**5.2 NO. 17 (LOT: 11; D/P: 2447) ST ALBANS AVENUE, HIGHGATE - PROPOSED ALTERATIONS AND ADDITIONS TO SINGLE HOUSE**

To consider an application for development approval for alterations and additions to a single house at No. 17 St Albans Avenue, Highgate (the subject site).

**GROUND FLOOR LANDSCAPING PLAN**  
1:200

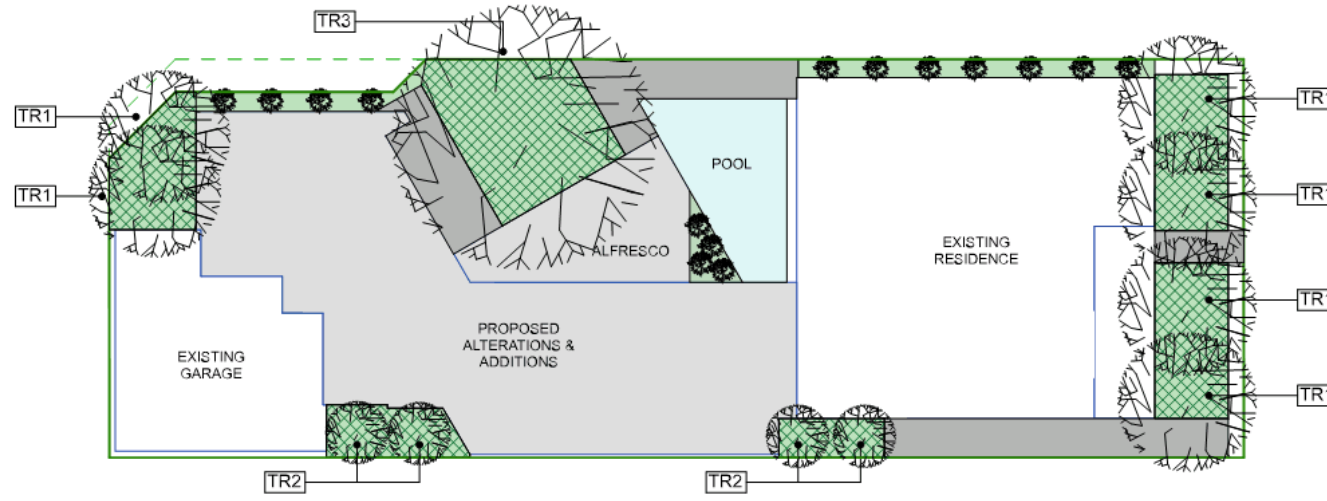
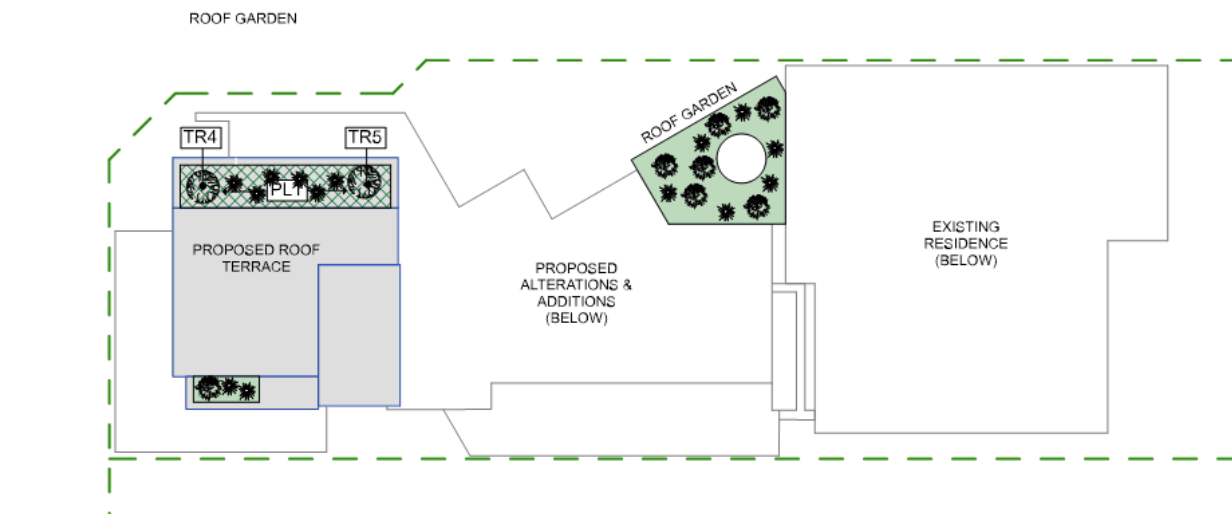
The Built Form Policy deemed-to-comply standards requires 12 percent of the site to be provided as deep soil areas, 3 percent of the site to be provided as planting areas, and 30 percent of the site to be provided as canopy coverage at maturity. The application proposes 12.7 percent deep soil areas, 5.1 percent planting areas, and 29.0 percent canopy coverage at maturity.

**PROPOSED ROOF TERRACE FLOOR PLAN**  
1:100

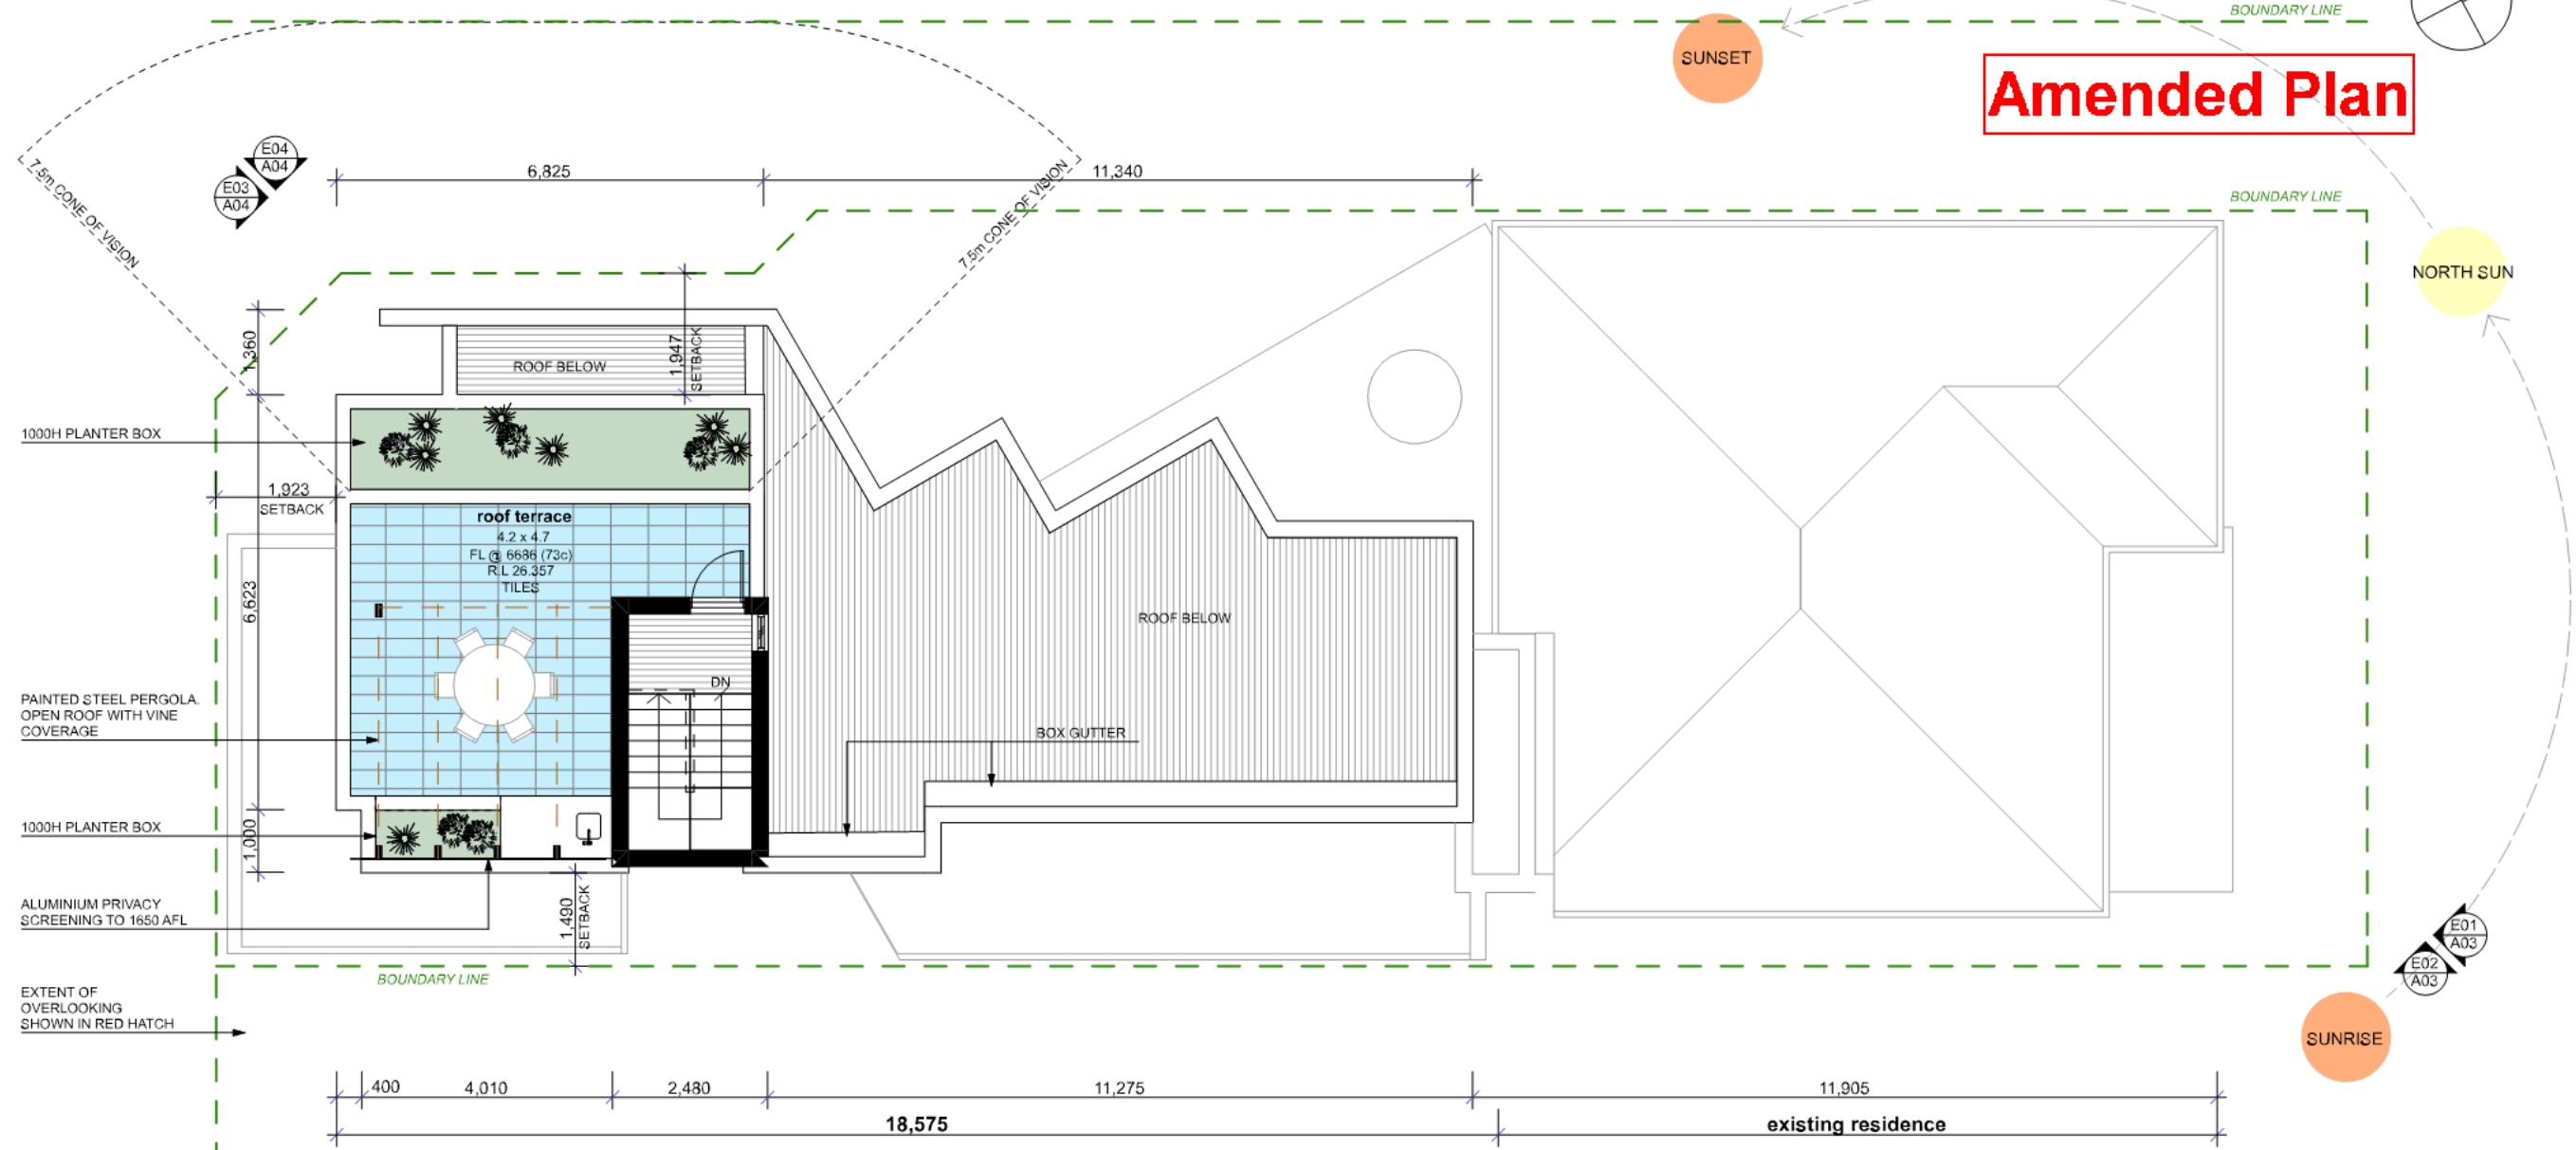
Privacy screening shall be extended for the full length south eastern edge of the roof terrace. The privacy screening shall have a height of 1.6 metres above the floor level of the roof terrace to satisfy the deemed-to-comply provisions of the Residential Design Codes Clause 5.4.1 – Visual Privacy in relation to the property to the south east (refer to advice note 13).

Prior to occupancy or use of the development, the roof terrace planter boxes shall be installed, to the satisfaction of the City. The roof terrace planter boxes shall not be removed unless the further approval of the City is obtained or privacy screening with a height of 1.6

metres above the finished floor level of the roof terrace is installed to ensure compliance with the deemed-to-comply requirements of the Residential Design Codes Clause 5.4.1 - Visual Privacy in relation to the properties to the north west, to the satisfaction of the City;

- The applicant is proposing a 1.5 metre wide built in planter box with a depth of 1.0 metre to the north western edge of the rooftop terrace. This planter would effectively increase the setback of the terrace from 6.0 metres to 7.5 metres. Further to the physical setback that this planter box would provide, it would also serve as a screening device to restrict the vertical cone of vision and limit the ability to look down into the rear backyards of the adjoining properties on the opposite side of the ROW, making any views oblique rather than direct. Should the application be approved, it is recommended that a condition be imposed requiring this planter box to be installed prior to occupation and not be removed unless further planning approval is granted;

Figure 2: Site Section

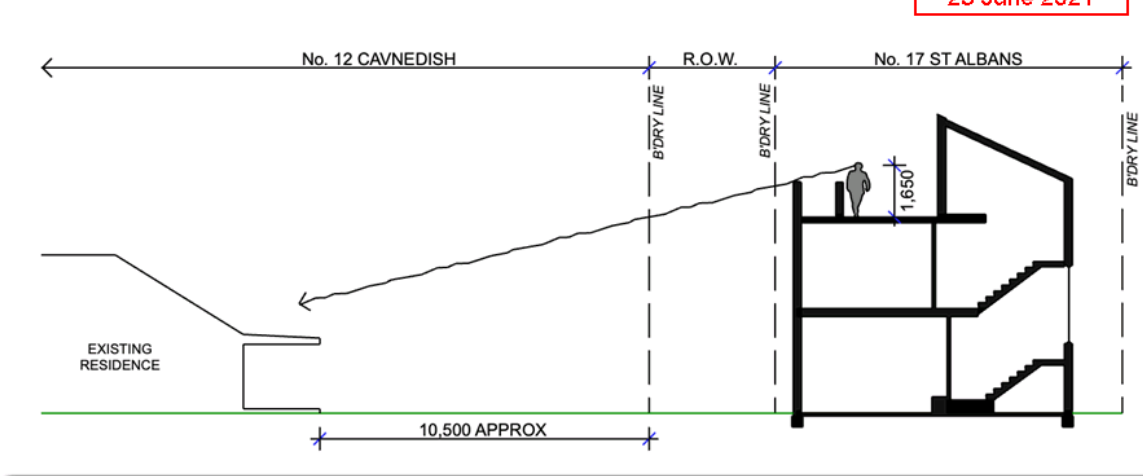
Minimise the extent of overlooking and resultant loss of privacy on adjoining properties.	<p>The location and height of the proposed wall provides screening to the neighbouring properties from the proposed roof terrace (refer to Figure 2).</p>
